U. S. Nuclear Regulatory Commission
ATTN: Document Control Desk
Washington, DC 20555-0001**Dresden Nuclear Power Station, Units 2 and 3
Facility Operating License Nos. DPR-19 and DPR-25
NRC Docket Nos. 50-237 and 50-249****Subject: Additional Information Regarding the Request for License Amendment Related to Heavy Loads Handling**

Attachment 1
Additional Information Regarding Request for License Amendment Related to
Heavy Loads Handling

Responses to NRC Questions

SECTION C-C (UPPER AREA)

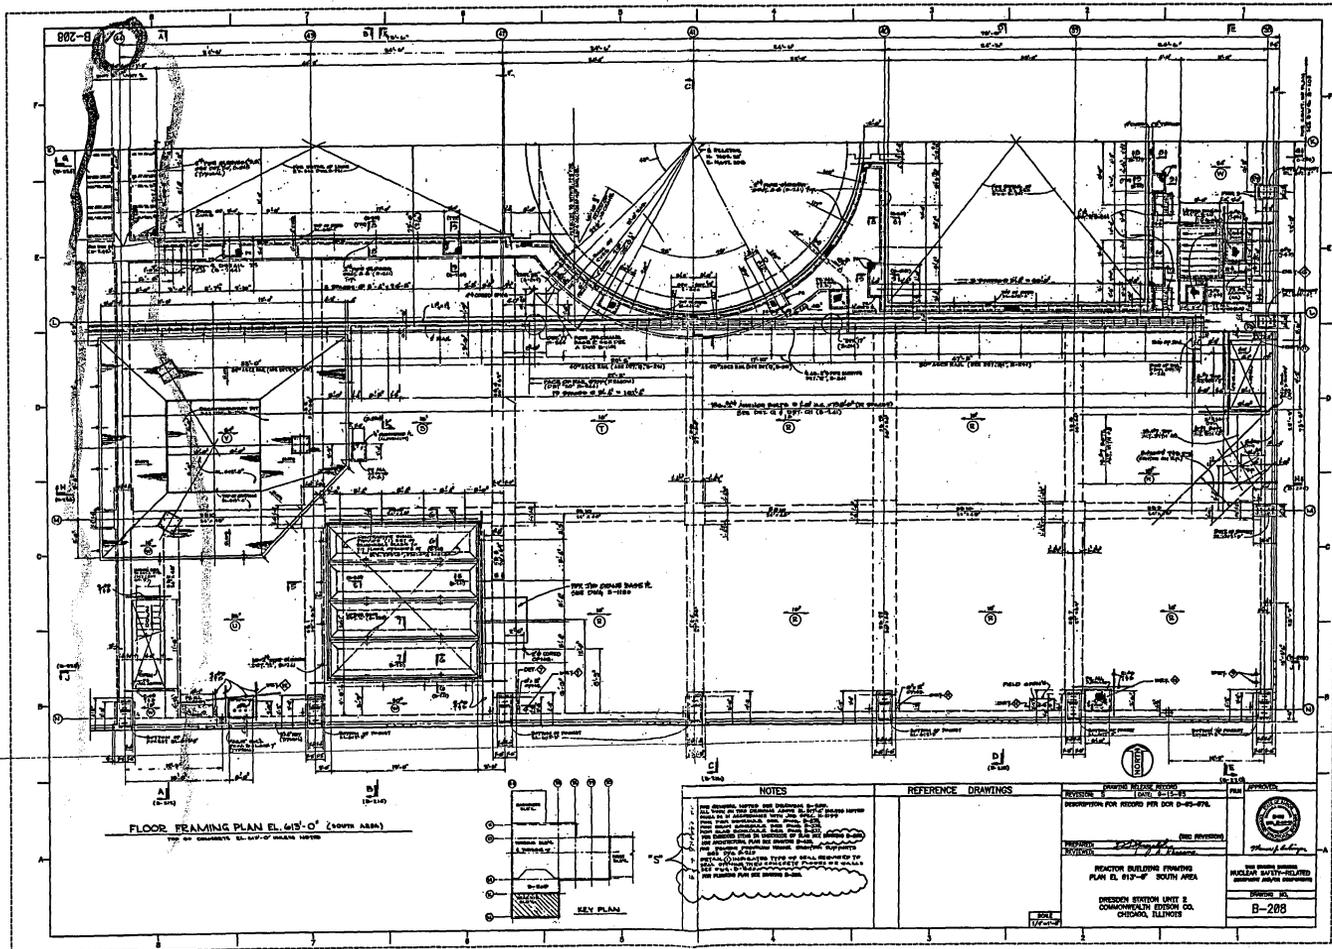
Provide a drawing or illustration of the maximum height that a top shield plug can drop and explain why this height is the maximum possible drop height.

Attached drawing B-216 (Section C-C) shows the three layers of the shield plugs located over the reactor cavity before the top shield plug is lifted.

Pages 28 thru 37 of Reference 2 provide the analysis for lifting of the shield plugs (including top layer plugs) above the reactor cavity, for a height of up to 1'-0" above the floor at elevation 613'-0". Therefore, the load drop of the top layer shield plugs, from a maximum height of 1'-0" above the floor level at the reactor cavity, has been analyzed.

REACTOR BLDG. FRAMING PLAN, EL. 613'-0", SOUTH AREA

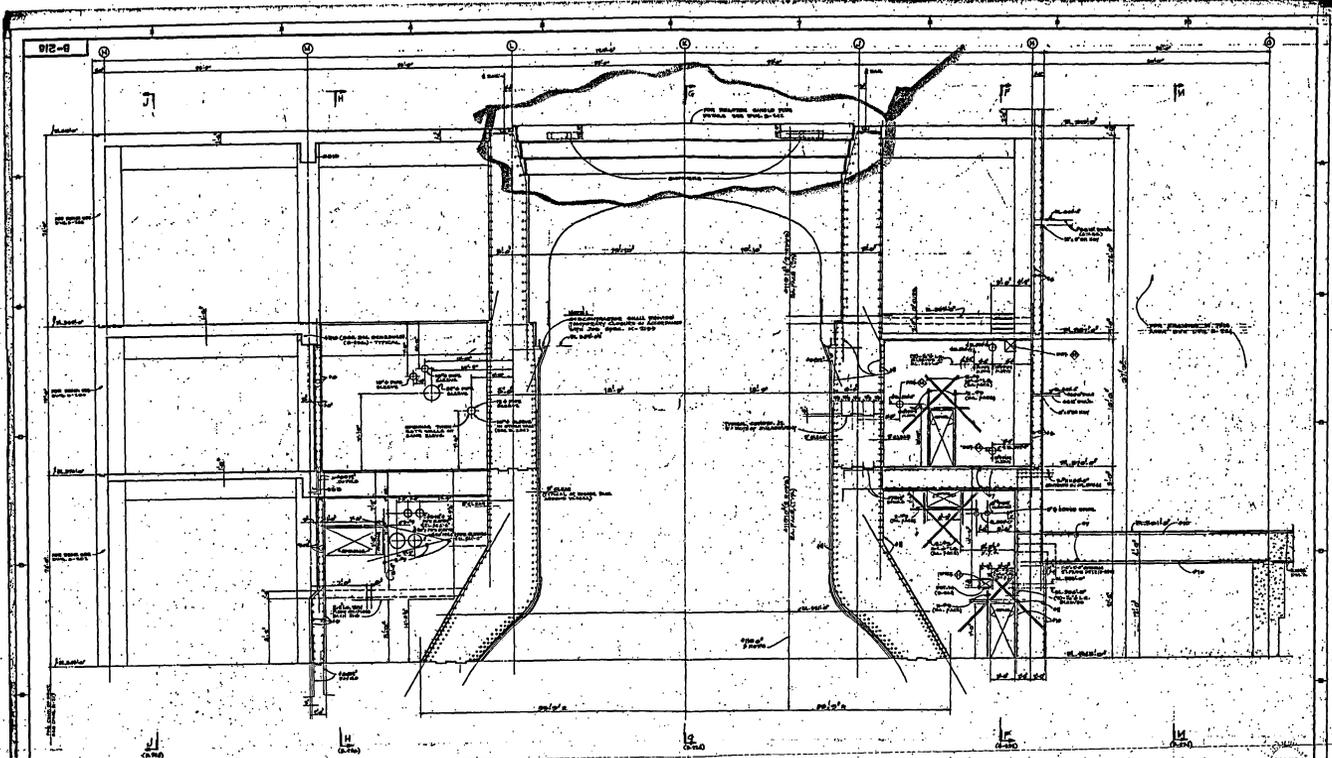
The full drop of a shield plug on a system of two adjacent slabs with a beam in between the slabs, is analyzed as Scenario 3 of the load drop analysis. In this calculation the combined beam and slab moment resistance factor, as discussed on page 68 of 95, is obtained on the basis of an equation provided on this page. Provide an explanation of how this equation reduces the beam moment resistance that accounts for the area of the two adjacent slabs as indicated.

Based on the sizes of the end restraint members for the wall at Column Row 44 (Reference 2, pages 87-90), and the fact that the wall ends at plant elevation 613'-0" (see attached drawing B-208) and is continuous at elevation 589'-0" (see attached drawing B-226), the wall was considered to have "one end unrestrained and the other end restrained."

Beam 5B6 flexural resistance is calculated on pages 52-56 of Reference 2 (see attached drawing B-208). This beam supports two identical slabs, one on each side. The slab flexural resistance is calculated on pages 62-66. The slab flexural resistance is computed on the basis that beams exist on all the four sides to resist the reactions of the loaded slab. For each of the two slabs, the beams are available to resist the reactions from three sides. The fourth side of each of the two slabs is resisted by beam 5B6. Therefore, this part of the slab resistance must be subtracted from the beam total resistance. This part amounts to one-fourth of the resistance of each slab.

For these end conditions, value of "K" on page 543 of Reference 3 is 0.7. This same value 0.7 is also shown as the theoretical "K" value in Reference 4 on page 5-135. However, this same table recommends using design value of 0.80 for "K" for these end conditions when ideal conditions are approximated. Accordingly, Reference 2 on page 89, conservatively considers the value of "K_{wall}" as 0.8.
